April 14, 2017

Re: **Open House April 11, 2017**
Design multi-use path 117th Ave. between Burnett Street and 231 Street

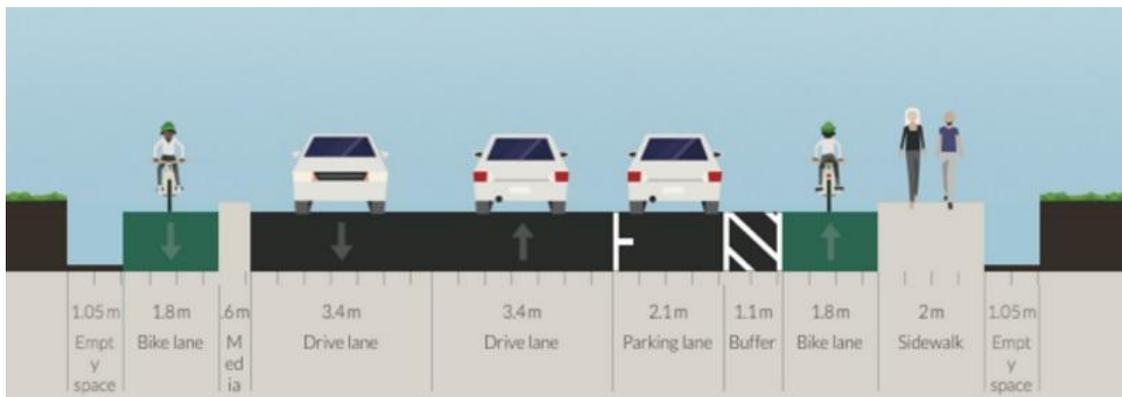
Despite these good arguments, we have strong reservations about the proposed design for the following reasons:

- As shown in research by Harris et al¹ (figure 2), the risk is about 8 times higher when a cyclist is coming in the direction opposite to expectation, compared to the expected direction. The same research paper (figure 3) also shows that multi-use paths have a slightly higher risk than bike-only paths at non-intersection locations.

- We recognize the benefit of a raised crossing; however, with about 20 driveways along the 500 meter stretch of 117th Ave., there are a significant number of locations where potential conflict can occur between those walking and biking in both directions, and cars.

- Parked cars and trucks along the multi-use path means reduced visibility of people on bikes and pedestrians (especially child-sized ones) to drivers crossing the bi-directional multi-use path onto a driveway.

- Anecdotal evidence suggests that without bollards, the chance of cars being parked on a wide pathway such as the one proposed is high. It's a very common problem. For example, parked cars are frequently seen on the new 203rd Street separated cycle track.

- If one bollard is placed on each side of each driveway, at least 40 bollards will be needed along 117th Ave. Bollards pose a hazard to people on bikes. Should the design for a multi-use path be selected despite our concerns, it would be preferable to use flexible plastic bollards, with reflectors, rather than the ones commonly used in Maple Ridge, which can lead to serious injury. We would recommend installation of the bollards during initial construction of the path.

- A bi-directional MUP on the north side of the road means that residents from the neighbourhoods to the south will need to cross 117th at various locations to reach the multi-use pathway as there is no space available to walk or bike on the south side.

- Having cycling facilities consistently on both sides of the road provides continuity and better access for residents, and should be the preferred solution where possible.

As our preferred solution, we would suggest something like the following lay-out:

- **Preferred option #1:** The bike lane on the north side should be grade separated from the roadway and painted green, to alert drivers to the potential presence of cyclists.

- **Second choice option #2:** The bike lane on the north side could be at roadway level, painted green. Placement of bollards would not be necessary, and it's more likely that cyclists and pedestrians will each use their own space. Potential disadvantage: drivers may not slow down sufficiently for the bike lane, as only the sidewalk will be raised.

- The sidewalk on the north side should be grade separated from the bike lane.
 - This will discourage pedestrians from using the bike lane instead of the sidewalk.

- The grade separations between roadway and bike lane and bike lane and sidewalk will slow down cars when turning into a driveway.
 - The grade separation between bike lane and adjacent sidewalk will discourage drivers from using them as a parking lane.

- A buffer between parked cars and bike lane will keep people on bikes out of the door zone, as well as improve sightlines for drivers turning into driveways.

- A raised curb or a "picket fence" could be used as a barrier to keep parked cars off the bike lane on the south side.
- Access for residents south of 117th Ave. is improved.

- Drive lanes can be narrowed to 10' to slow down cars.
- A crosswalk with elephant feet should be added to cross 117th Ave. between the pedestrian pathway and the bike lane on the south side.
